CITY OF ALBUQUERQUE

**RE: Sage Park Subdivision
Sage and Coors SW
Grading and Drainage Plan
Engineer's Stamp Date: 1/30/20
Hydrology File: L10D030**

Based on the submittal received on 1/31/20, this Grading and Drainage Plan cannot be approved until the following corrections are made:

CITY OF ALBUQUERQUE PUBLIC WORKS DEPARTMENT ENGINEERING DEVELOPMENT GROUP	
SAGE PARK SUBDIVISION	
A REPLAT OF TRACT 401, TOWN OF ATRISCO GRANT UNIT 3	
GRADING PLAN	
DESIGN REVIEW COMMITTEE	CITY ENGINEER APPROVAL
LAST DESIGN UPDATE	Mo./DAY/YR.
SHEET 2 OF 6

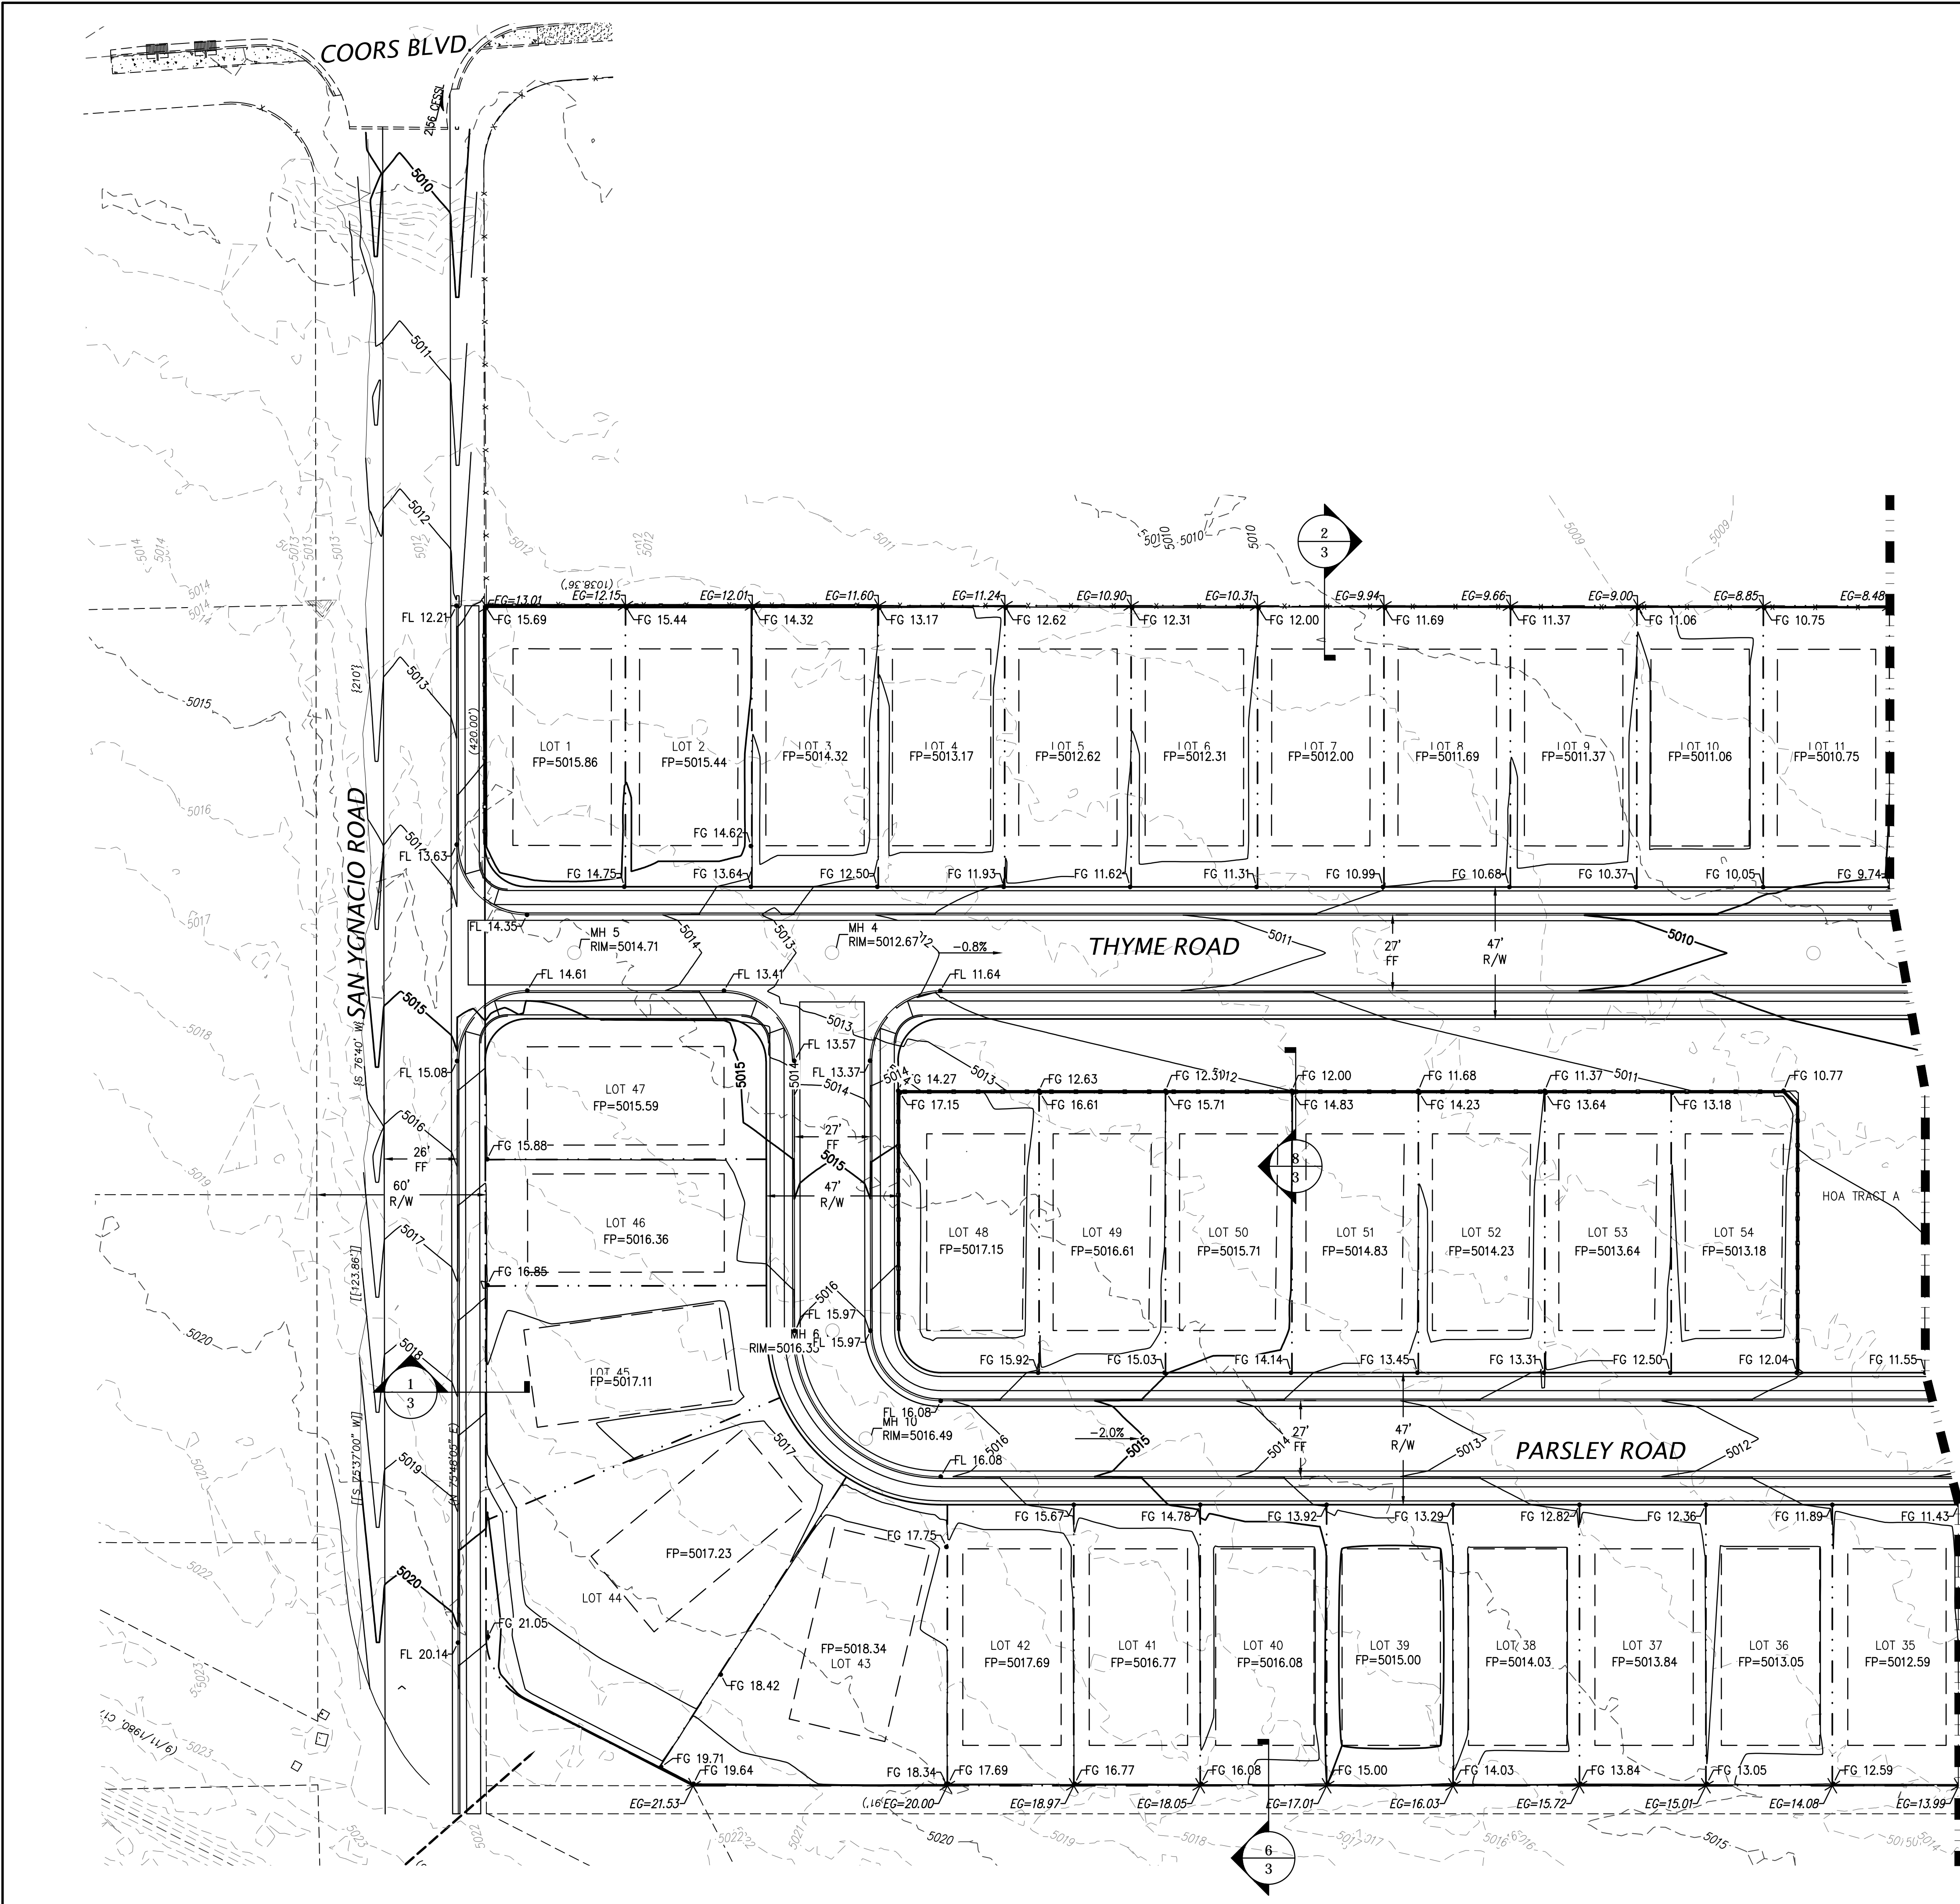
3. Street capacity calculations must show the water surface (HGL) contained in the road (top of curb) and the EGL contained in the ROW (most likely edge of sidewalk to edge of sidewalk). Standard curb and gutter or additional storm drain is probably needed in a few areas.

5. Provide waterblocks, 0.87' minimum (or energy and flow depth calculations) for the following intersections: San Ignacio & Thyme, Parsley & Sage.

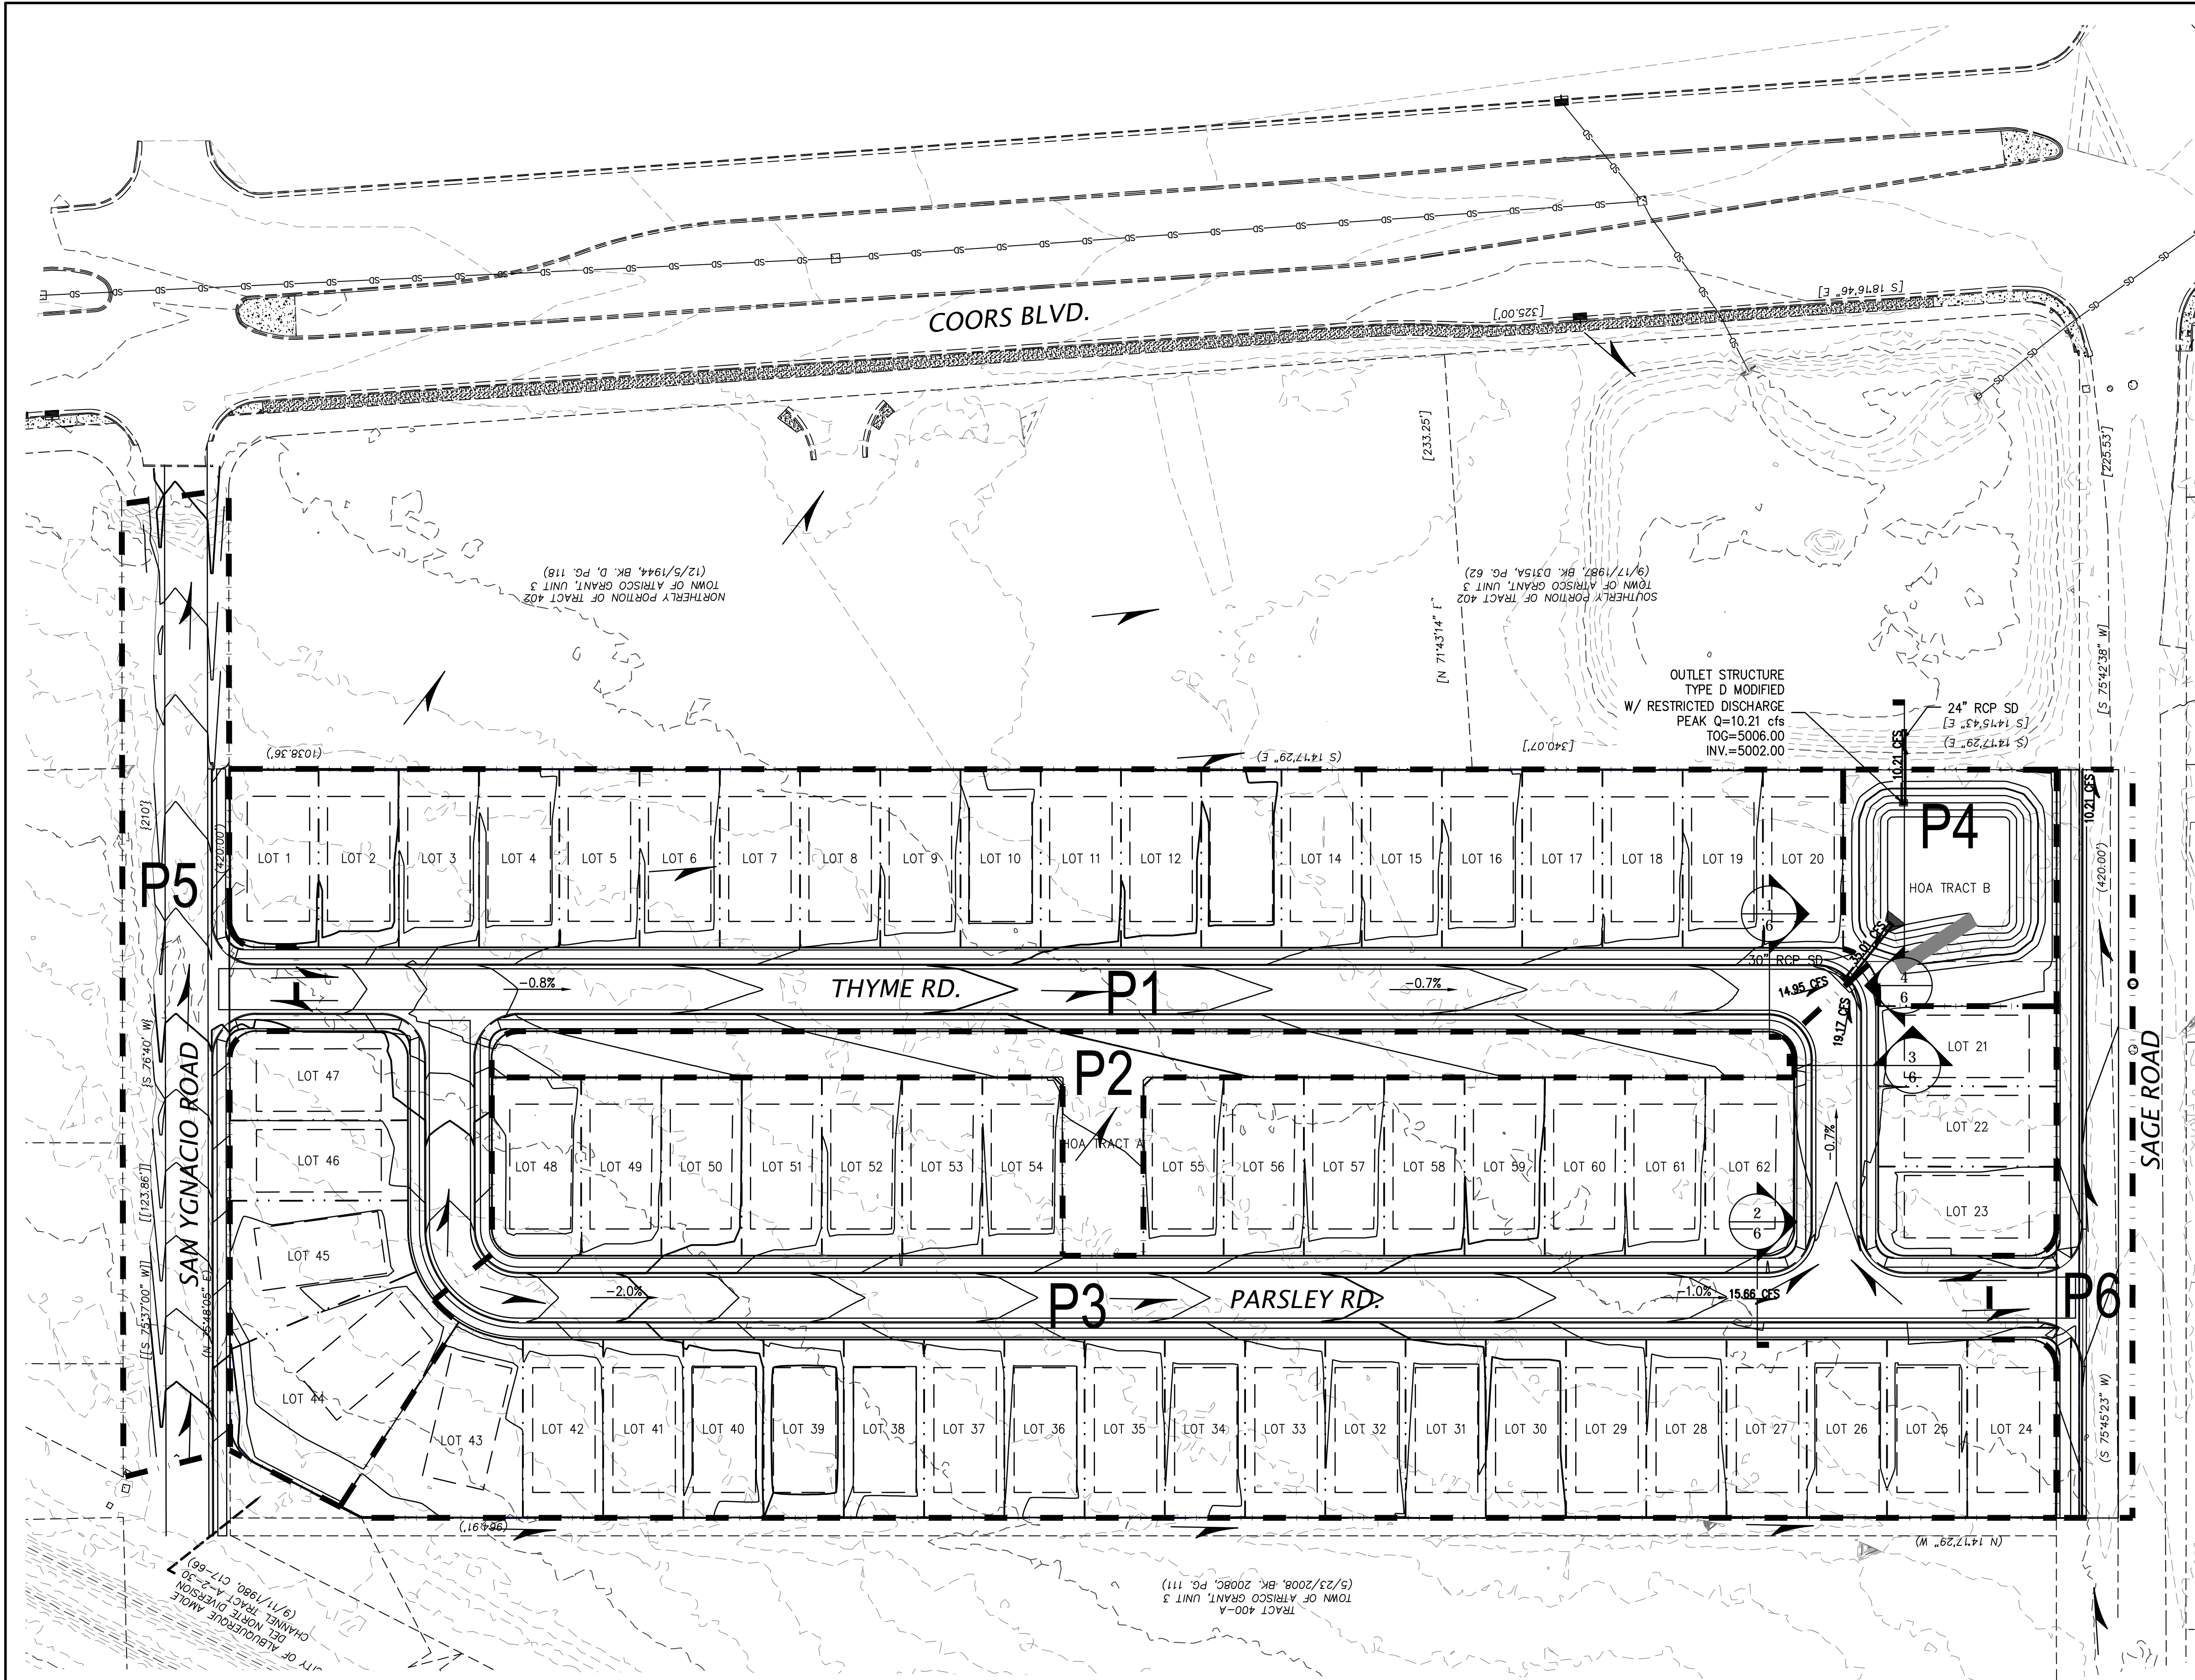
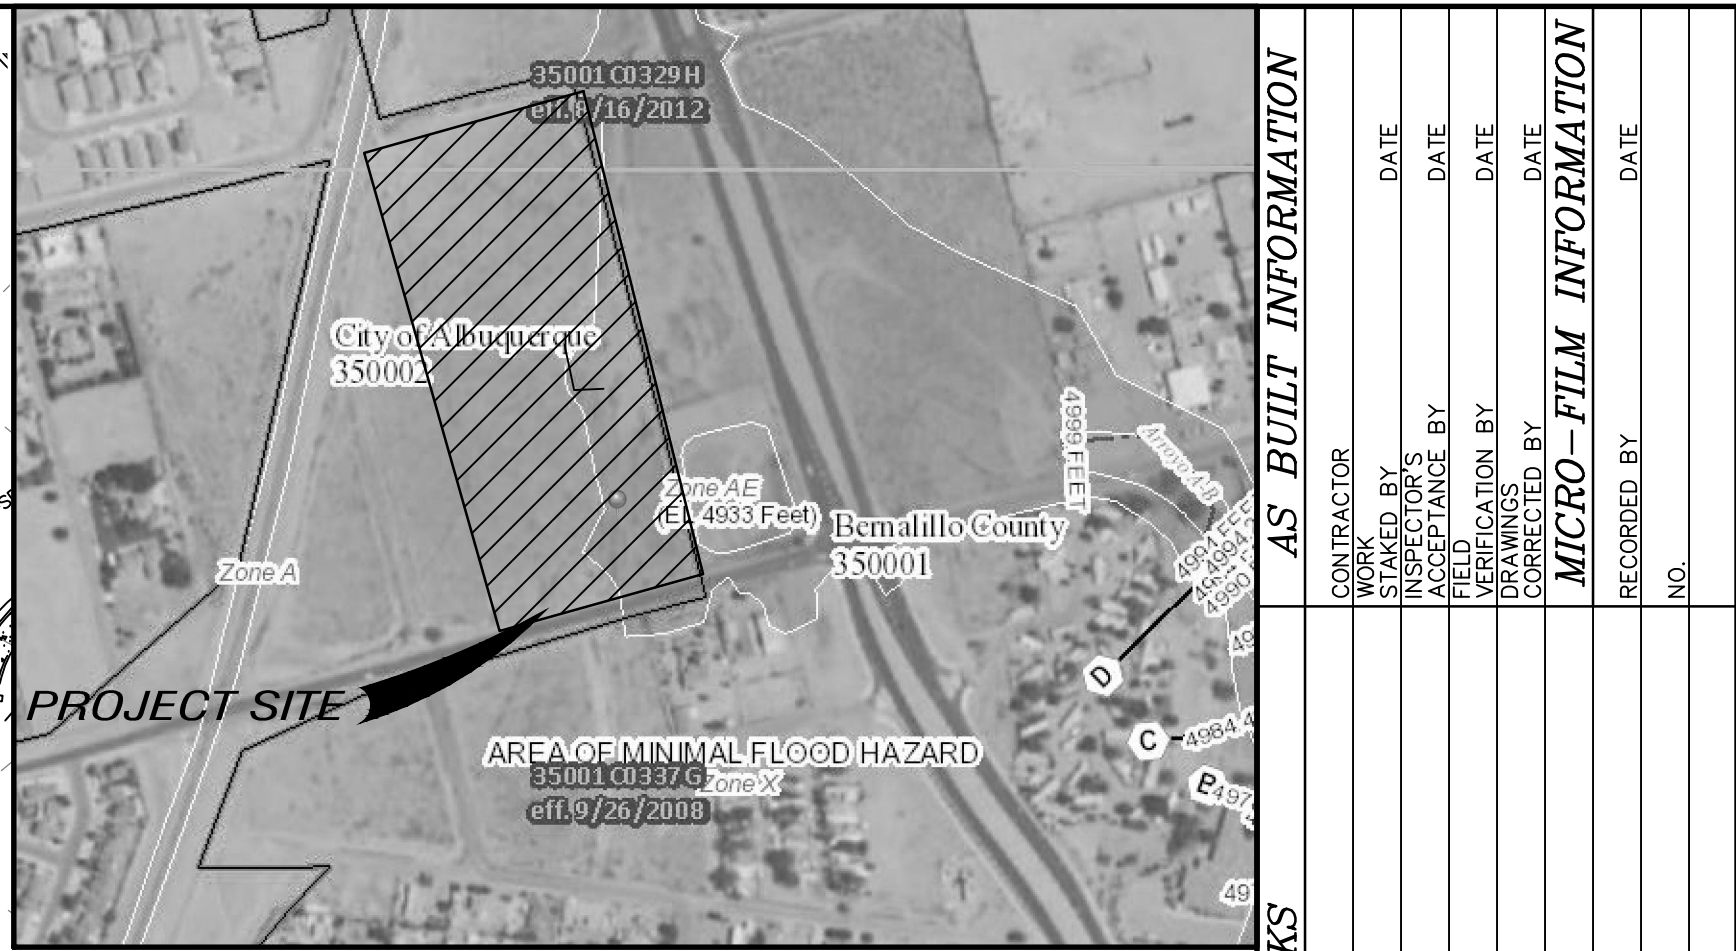
1. The site must demonstrate adequate downstream capacity per § 14-5-2-12(G) of the Albuquerque Code of Ordinances. This includes County permission for the work on their property and the right to discharge, as well as the hydraulic capacity. I cannot find any record of what the pond's function is or what areas it was built to serve, but it appears to be County owned and maintained. Any reports from the County used to show downstream capacity should be included in the resubmittal.

2. Complete Hydrologic (AHYMO files) and Hydraulic calculations need to be provided. The summary of results is helpful, but needs to be supported with all the underlying calculations, most likely in a bound Drainage Report.

4. The Hydrologic and Hydraulic analysis needs to include the upstream offsite basins. Notably, the area north of San Ignacio and the area between this subdivision and Amole Del Norte Diversion Channel.
